01-22-03 - Late Production - Update Programming Engine/Motor Control Module -J623-

Release date: 3/29/2022

Customer states there is low or no heat output from the air vents under certain cold weather conditions. This TB also proactively corrects faults listed below.

Figure 1.

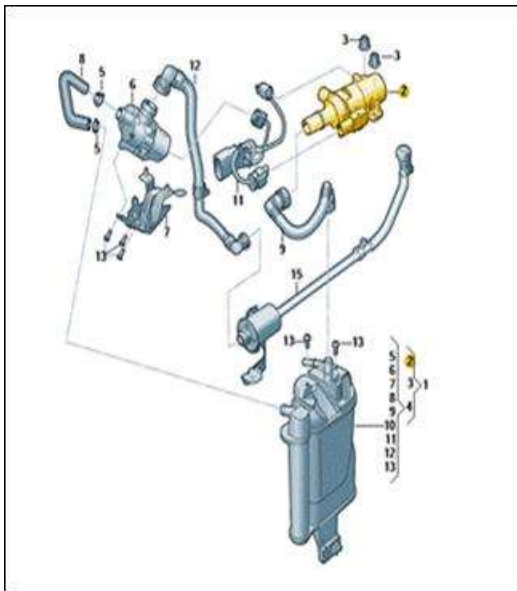
In addition to the software improvement, there is also an improvement to the FTIV (fuel tank isolation valve/tank switch-off valve -**N288**-) (Figure 1.), which is necessary in preventing erroneous occurrences of the P2421 fault code.

The FTIV / Tank switch-off valve -**N288**- currently installed on the vehicle must be inspected, to verify whether an improved part has already been installed. The FTIV / Tank switch-off valve -**N288**- is mounted to the EVAP canister assembly, as shown below.

Figure 2.

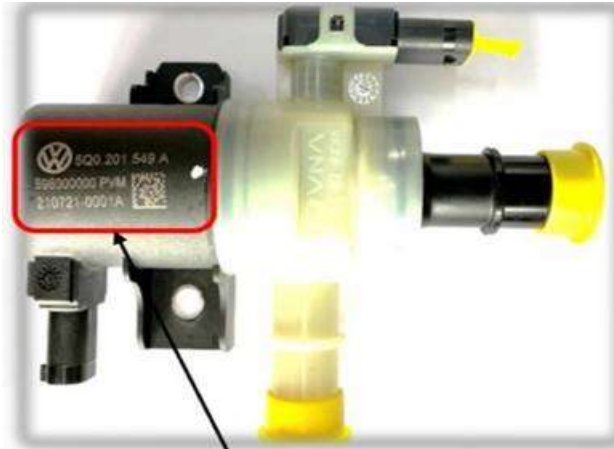
Remove the EVAP canister assembly and inspect the face of the FTIV / Tank switch-off valve -**N288**-. If the part is already updated, it will have a white paint marking or "02S" printed after the part number, as shown in Figure 2 and Figure 3.

- If the part has a white paint mark or "02S", the FTIV / Tank switch-off valve -**N288**- is already the updated component. In this case DO NOT replace it, and instead reinstall the EVAP canister assembly. Only the software update will be required.
- If there is no white paint mark or "02S" are visible on the FTIV / Tank switch-off valve -**N288**-, the component must also be replaced in addition to the software update. Always refer to ETKA for the most up to date part number information.
